To: T10 Technical Committee
 From: Rob Elliott, HP (elliott@hp.com)
 Date: 19 April 2006
 Subject: 06-166r3 SAS-2 Restrict access to SMP ZONED BROADCAST function

Figure 1 — ZONED BROADCAST from a rogue initiator port

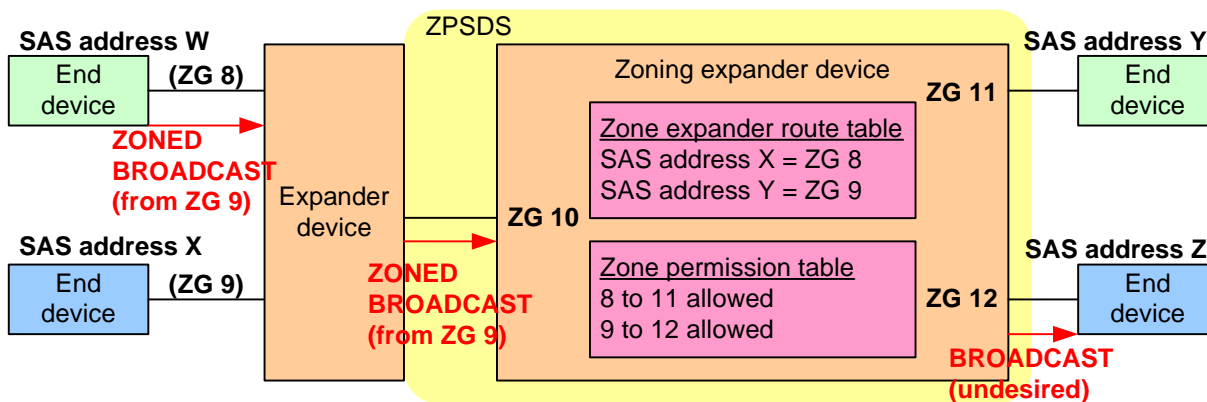
In sas2r03, the function can be sent by any SMP initiator port that has access to the expander device. This means an SMP initiator port in one zone group can introduce BROADCAST traffic into other zone groups (see figure 1), which somewhat defeats the purpose of zoning.

Access needs to be restricted so SMP initiator ports cannot sneak traffic into other zone groups unless they have permission.

Figure 2 — BROADCAST escaping zone

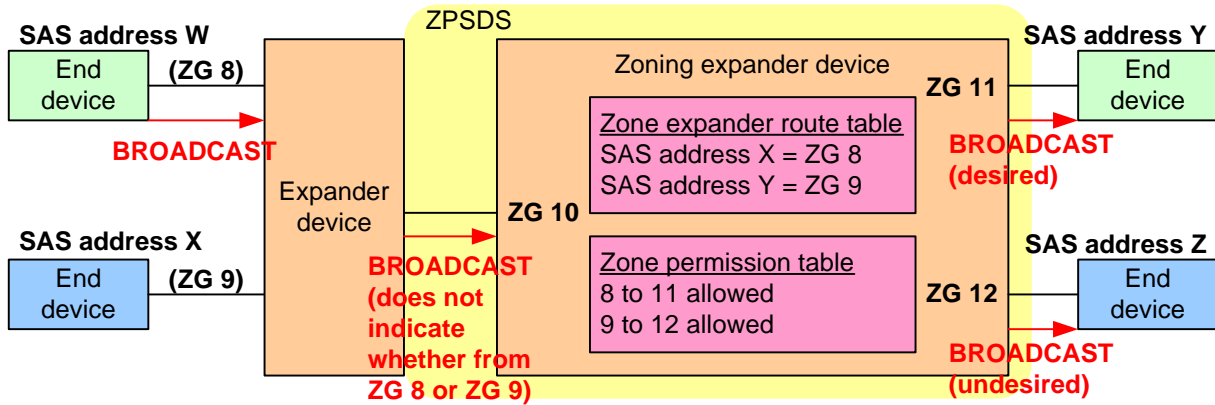
With the “zone address resolved” mode, an expander phy on the boundary of the ZPSDS that is attached to another expander device may be the entry point for traffic from devices in more than one zone group. However, since BROADCAST primitives do not carry source zone group information, an incoming BROADCAST primitive must be considered to have come from any of those zone groups. The expander device must treat it as coming from all the possible source zone groups and forward it to all destination zone groups to which all the source zone groups on that expander phy have permission (see figure 2). This is

undesirable.

A mechanism should be defined to allow the expander device outside the ZPSDS to identify the source zone group of the BROADCAST so it can be forwarded only to the proper destination zone groups. This cannot be perfect (since the expander device is not trusted), but it can limit the extent of the BROADCASTs if it is behaving (and anyway is restricted only to the zone groups that are sharing the door into the ZPSDS).

Figure 3 — BROADCAST kept in zone

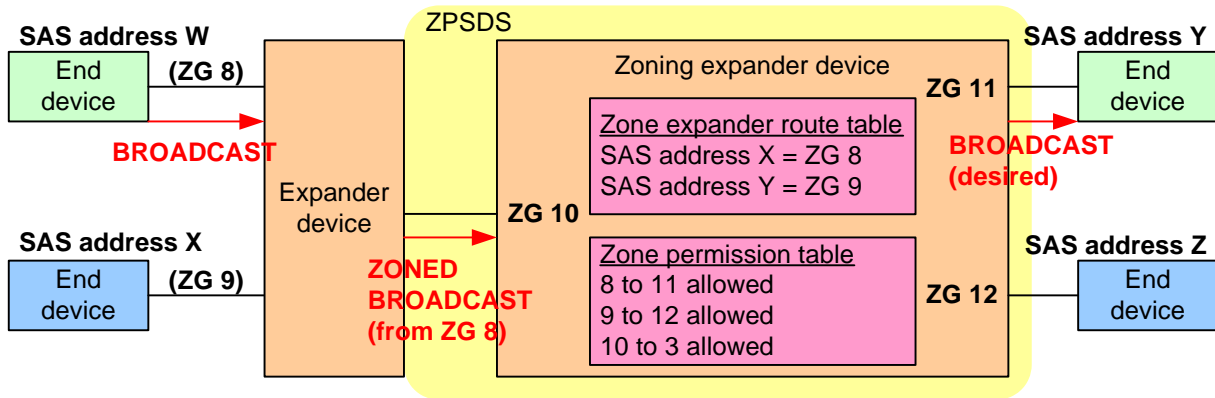
A new zone group 3 is proposed for this purpose. The zone permission table must indicate the SMP initiator port has access to zone group 3 for the SMP ZONED BROADCAST function to be allowed. This allows an external expander device, if its own source zone group has access, to use SMP ZONED BROADCAST (see figure 3).
